# Access Compliance Report

## Public Rights-of-Way

### (Curb Ramps)

Intersection ID: 11124	Main Street: N_CLARKSON_ST	Cross Street: CATES_ST	Location: W
ADA ID: B329BA299CB8	Ramp Type: PerpDiag	Initial Pass/Fail: Fail	Overall Compliance: No
Severity Score: 12.5			
Codes/Mitigation Info/Possible Solution		Field Measurements/Component Compliance

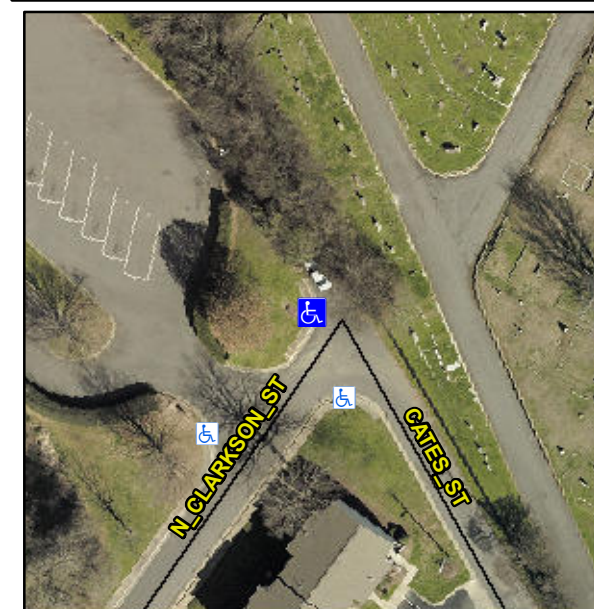
**Not Found, R304.2.2**

Compliance	Description	Data	Compliance	Description	Data
N/A	Ramp Length (in)	51.0	No	Ramp Slope (%)	9.2
Yes	Ramp Width (in)	64.0	Yes	Ramp XSlope (%)	1.1
N/A	Flare Type LT	N/A	N/A	Flare Type RT	N/A
N/A	Flare Slope LT (%)	N/A	N/A	Flare Slope RT (%)	N/A
N/A	Flare Traversable LT?	N/A	N/A	Flare Traversable RT?	N/A
N/A	Landing Length (in)	N/A	N/A	DWS Provided?	N/A
N/A	Landing Width (in)	N/A	N/A	DWS Contrast?	N/A
N/A	Landing Slope (%)	N/A	N/A	DWS Length (in)	N/A
N/A	Landing X Slope (%)	N/A	N/A	DWS Full Width?	N/A
N/A	Landing Curb? (Y/N)	N/A	N/A	DWS Offset (in)	N/A
N/A	Shared Landing?	N/A			
N/A	Gutter Ponding?	N/A	N/A	Gutter Slope (%)	N/A
N/A	Gutter Lip Ht (in)	N/A	N/A	Gutter X Slope (%)	N/A
N/A	Painted X Walk1?	No	N/A	Painted X Walk2?	No
	X Walk 1 Direction	To S		X Walk 2 Direction	To E
N/A	X Walk 1 Width (in)	N/A	N/A	X Walk 2 Width (in)	N/A
	X Walk 1 Slope (%)	6.4		X Walk 2 Slope (%)	0.8
	X Walk 1 X Slope (%)	2.2		X Walk 2 X Slope (%)	6.1

**Remove & Replace Curb Ramp With Two New Directional Ramps or Equivalent.**
